DESCRIPTIVE REPORT

Field No. Office No. T-13121

Locality Bahia Fosforescente

REVIEW REPORT T-13121
SHORELINE
June 5, 1970

T-13121

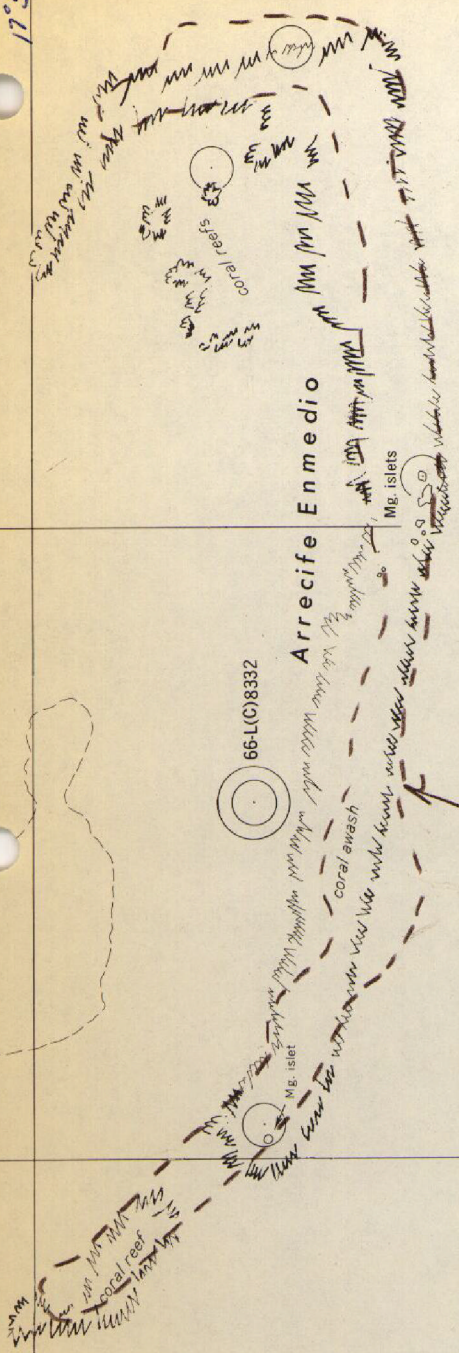
Not all of ^{the} offshore reefs are shown on the registered survey. Those that are shown are symbolized by dots. The comparison of the reefs has been indicated on the comparison print with a blue dashed line; the comparison with the shoreline with a solid blue line.

The shoreline of the USGS quadrangle is not in good agreement with that of T-13121. Isla Magueyes appears to be displaced approximately 90 meters in a southeasterly direction. All differences between the two surveys, including the offshore reefs, have been noted on the comparison print in brown.
